**FFERM WYNT ALLTRAETH AWEL Y MÔR ARFAETHEDIG / PROPOSED AWEL Y MOR
OFFSHORE WINDFARM**

**CYFEIRNOD YR AROLYGIAETH GYNLLUNIO / PLANNING INSPECTORATE REFERENCE:
EN010112**

RE: NATURAL RESOURCES WALES' WRITTEN SUBMISSION FOR DEADLINE 1

Figure 1: location of Great Ormes Head / Pen-y-Gogarth SSSI.

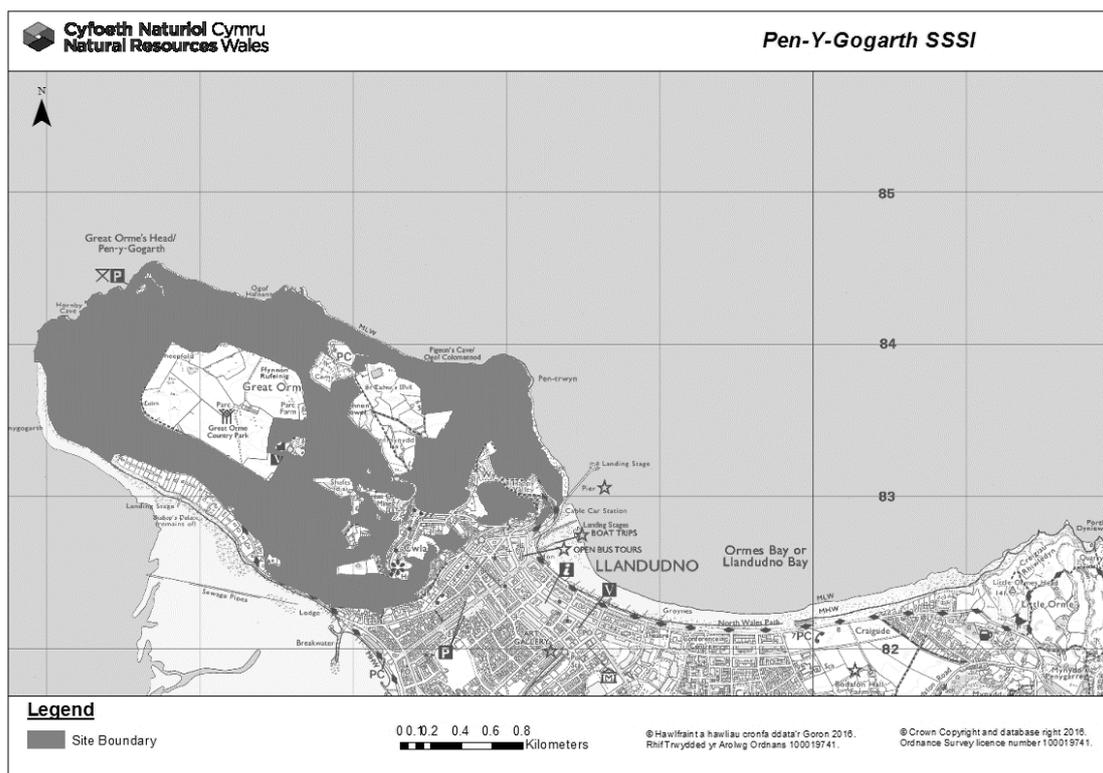
- 2.6.3. The proposed location for Awel-y-Môr is approximately 10km from Pen-y-Gogarth / Great Ormes Head Site SSSI (Figure 1; hereafter referred to as Pen-y-Gogarth SSSI). The cliffs host a large colony of breeding seabirds, and the site is designated for breeding Kittiwake, Guillemot and Razorbill. This is the second largest Kittiwake breeding colony in Wales and the largest in North Wales, supporting approximately 821 pairs each year (5-year mean of peak counts 2017-2022 = 821 pairs, excluding 2020 when no data were collected due to the COVID-19 pandemic). In addition, the site supports around 2149 breeding pairs of Guillemot and 236 breeding pairs of Razorbill each year (figures also based on 5-year mean peak 2017-2022 excluding 2020).

Figure 2: showing the Awel y Môr Order Limits overlaid with the buffers from the White Consultants' report for a Low magnitude of effect

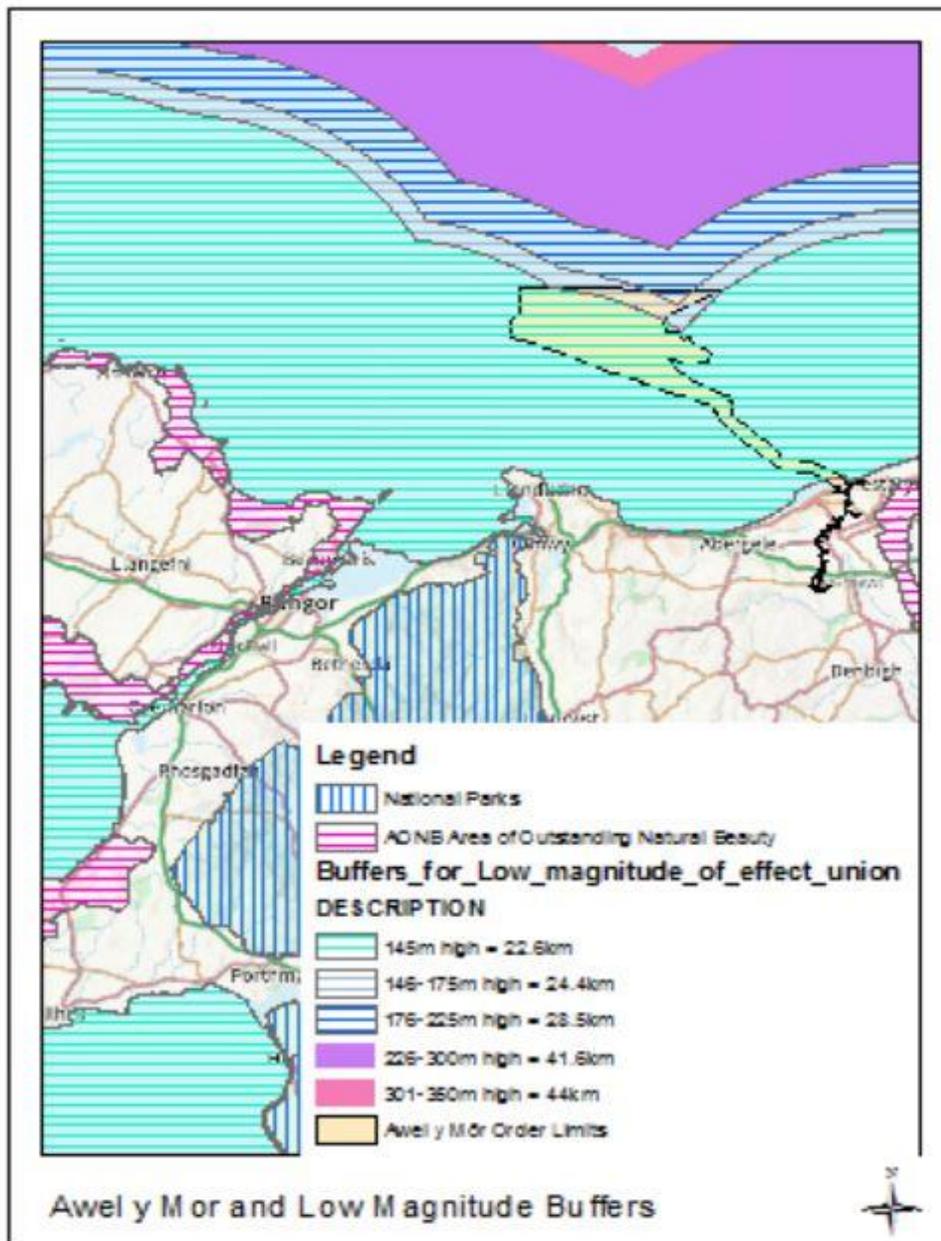
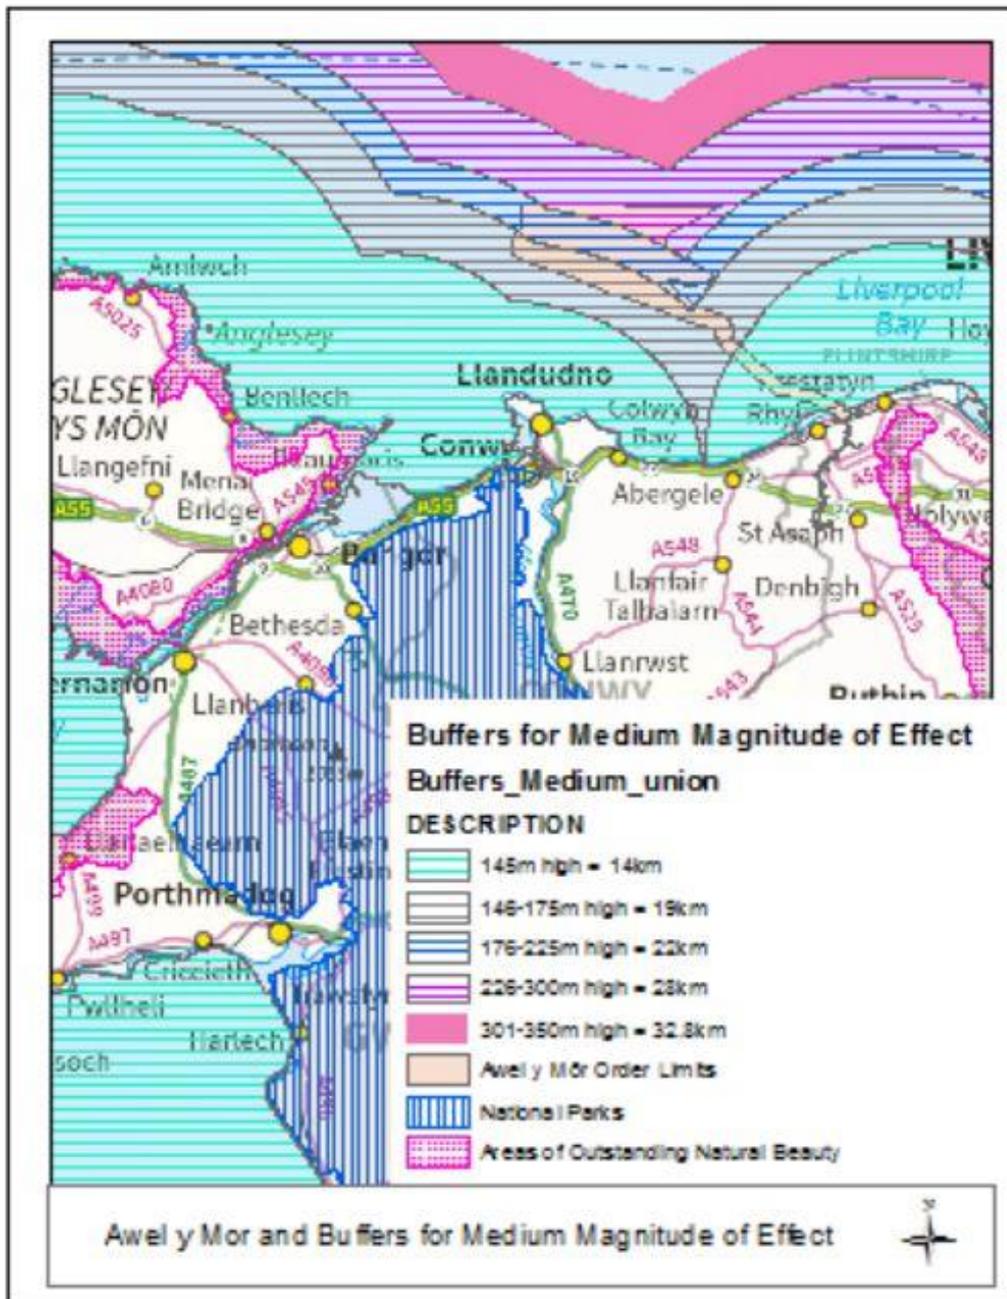
- 3.1.24. In our Relevant Representations we advised that further consideration be given to NRW's evidence base "*Seascape & visual sensitivity to offshore wind farms in Wales: Strategic assessment and Guidance*" (White Consultants for NRW, March 2019⁷) to assist in informing an appropriate reduction in the extent/scale of the proposed development. NRW had previously advised the Applicant of this in our section 42 consultation response on 8th October 2021. However, the Applicant has not followed the guidance in this document. The document comprises commissioned research reports relating to designated landscapes taking the form of an evidence base (Stage 1 report), strategic siting guidance (Stage 2 report), and the application of 1 and 2 in a sensitivity assessment (third report). The three reports should be read together. These reports indicate relative sensitivity in terms of buffer size and are typically used as one layer among others in a spatial constraints analysis.

Part 1 of Stage 3 identifies zones within the offshore area with differing levels of sensitivity. Part 2 provides a detailed sensitivity and capacity assessment for each zone. The proposal is located in Zones 1 and 2. **Zone 1**, adjacent to Gwynt y Môr is of medium sensitivity, and up to 22.6km from shore considered to have potential for a small extension, but scope is limited. Extending windfarm development westwards of Gwynt y Môr would cause cumulative effects on sensitive receptors. A small number of additional turbines may be possible, but cumulative effects and avoiding extending across the horizon from key viewpoints would need to be carefully considered. **Zone 2** is of medium/low sensitivity, and between 22.6 and 44km from shore and the evidence base indicates that potential development is dependent on the height of turbine and likely extent of the overall windfarm. Development beyond Gwynt y Môr would tend to limit harm. There is potential for combined cumulative effects on the Great Orme and Snowdonia if further windfarms or extensions extend west, especially closer to the shore. The area has the ability for further development to be accommodated north of Gwynt y Môr (but away from Douglas oil field). The size of the turbine should be similar to the existing development closer to the shore but can increase in height further offshore taking into account the visual impact analysis.

Figure 4: Extract from ES Vol 6 Annex 10.4 Fig 11 (Visual Receptors & Viewpoint Locations) illustrating the extent of adverse effects along the North Wales coast from Viewpoint 1 Bull Bay in the west to Viewpoint 24 Graig Fawr in the east and inland to Viewpoint 10 Carnedd Llewelyn.

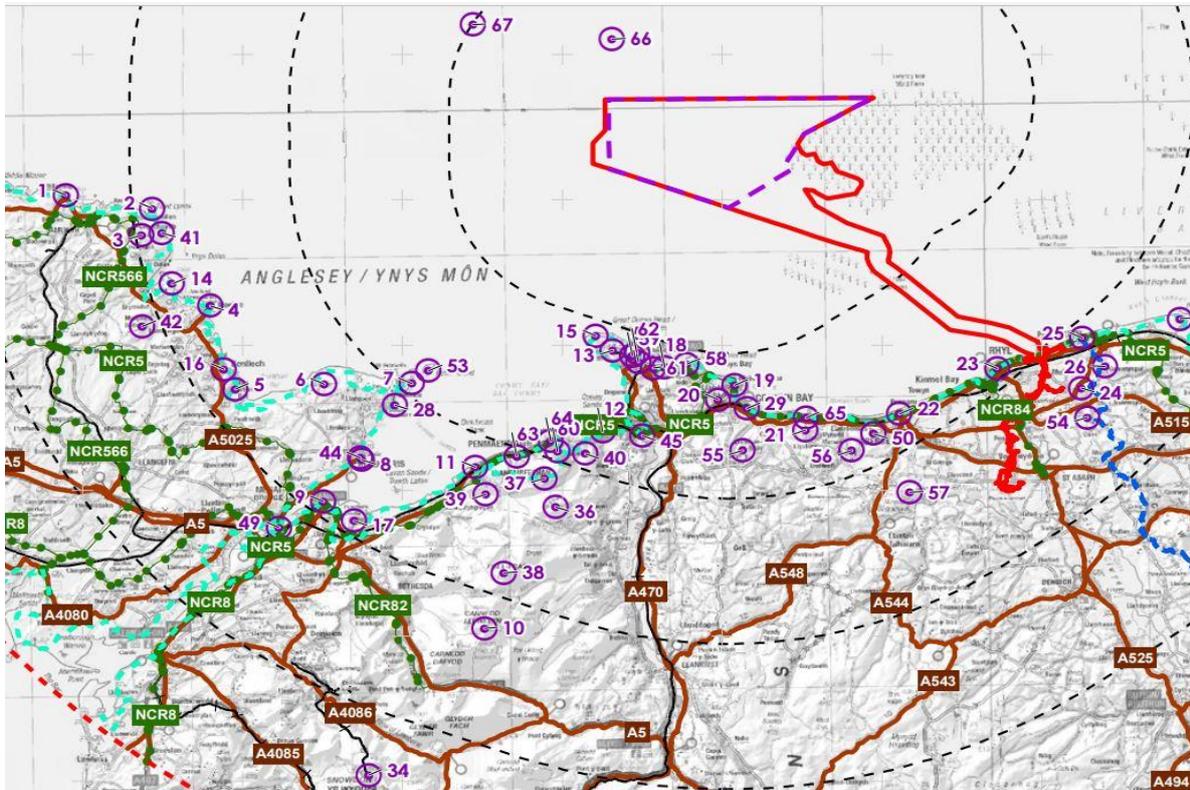
- 6.1.37. Adverse effects would be experienced along a substantive part of the North Wales coastline from Anglesey in the west to the Clwydian Range and Dee Valley AONB in the east.
